NEWMAR CORPORATION WARRANTY DEPARTMENT

TECHNICAL SERVICE BULLETIN							
DATE ISSUED	MODEL YEAR(S) AFFECTED	MODEL(S) AFFECTED	TSB #				
12/7/92	1992-1993	ALL	68				
BRAND		TYPE					
All <input checked="" type="checkbox"/>	American Star <input type="checkbox"/>	Kountry Star <input type="checkbox"/>	Dutch Star <input type="checkbox"/>	All <input checked="" type="checkbox"/>	T T <input type="checkbox"/>	F W <input type="checkbox"/>	
NewAire <input type="checkbox"/>	Mountain Aire <input type="checkbox"/>	Kountry Aire <input type="checkbox"/>	London Aire <input type="checkbox"/>	C A <input type="checkbox"/>	D P <input type="checkbox"/>	D B <input type="checkbox"/>	
<input type="checkbox"/> Air Conditioning & Heating				<input checked="" type="checkbox"/> Electrical Components			
<input type="checkbox"/> Appliances & Accessories				<input type="checkbox"/> Exterior Components			
<input type="checkbox"/> Cabinets & Furniture				<input type="checkbox"/> Interior Components

Winegard
F.Y.I.

November 1992

Poor reception

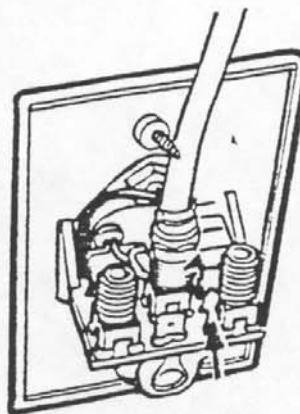
Problem: The customer complains of poor reception when the on/off switch is in the "cable" position. The mounting screws supplied with the RV-0710/0731/0741/7010/7031 may be too long. The mounting screw may have penetrated the coax cable when installing unit in wall. This problem began with a design revision in October 1992 when the fuse was removed and jack configuration changed.

Solution: Back out the 1" top screw and either cut off 3/8" or replace with our part no. 2160145 ivory, 2160146 brown or 2160147 white. These replacement screws are available at no charge upon request. New production (begun 11/23/92) will be using shorter length screws. Cable should be replaced.
